Model: FR6 (FAX 3800L)		Date: 15-Feb-98	No: 001
Modified Article: FCE		Prepared by: Y.Okunishi	
From: QAC Field Information Dept.			
Reason for Modification:	<input type="checkbox"/> Parts catalog correction <input type="checkbox"/> Vendor change <input type="checkbox"/> To meet standards <input type="checkbox"/> To facilitate assembly <input checked="" type="checkbox"/> To improve reliability    (      ) <input type="checkbox"/> Part Standardization <input type="checkbox"/> Other		
Modification Schedule	December 1997.

Model: FR6 (FAX3800L)		Date: 15-Feb-98	No: 002
Modified Article: FCE		Prepared by: Y.Okunishi	
From: QAC Field Information Dept.			
Reason for Modification:	<input type="checkbox"/> Parts catalog correction <input type="checkbox"/> Vendor change <input type="checkbox"/> To meet standards <input type="checkbox"/> To facilitate assembly <input checked="" type="checkbox"/> To improve reliability    (      ) <input type="checkbox"/> Part Standardization <input type="checkbox"/> Other		
Modification Schedule	February 1998.

Model: F/L Series, FR6 (F66), FR4 (F64)		Date: 31-Oct-98	No.: 201
Modified Article: Development Unit		Prepared by: Y.Okunishi	
From: GTSS Field Infor

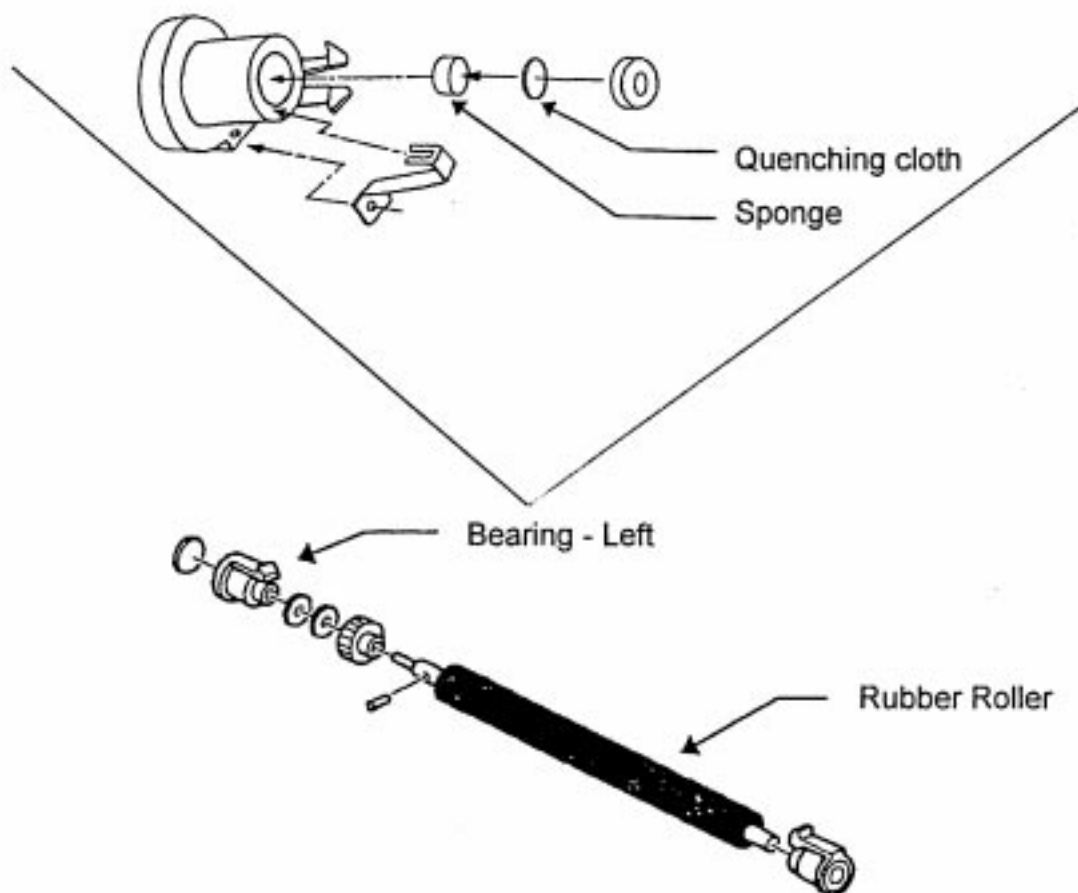
### 1) Rubber Roller

The mold of the rubber roller is changed to a new type which is the same mold as for the other models.

As a result, the surface of the rubber is changed slightly (it is not easy to see the change visually.) and this is effective in preventing the toner from sticking on the roller surface. (See "Filming Problem" in RTB no. F/L - 064.)

### 2) Bearing – Dvlp. Roller – Left

Small parts, which make better grounding, are added inside the bearing. See below. If the grounding is not completed, vertical black lines may occur on copies.

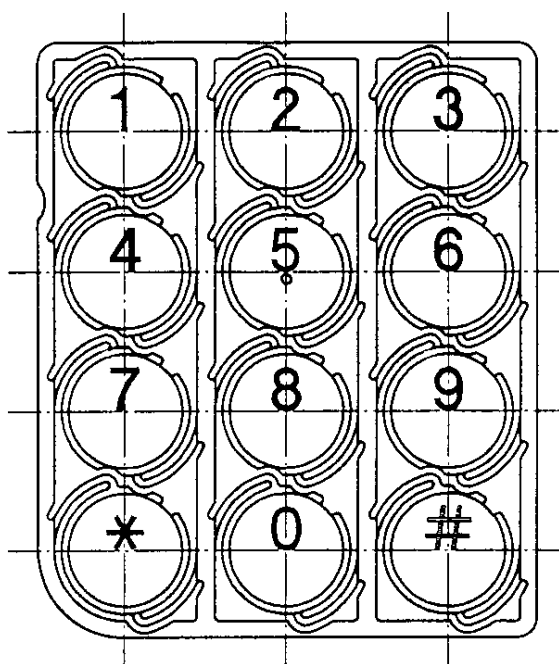
Old part number	New part number	Description	Q'ty	Int	Page	Index	Note
<b><i>08053386</i></b>	H5151348	Needle Roller Bearing - 4x8x8	1-1	X/O	10	110	*1
H5151342	H5511342	Polyethylene Sheet	2-2	O/O	7	33	*2

\*1: For part catalog correction
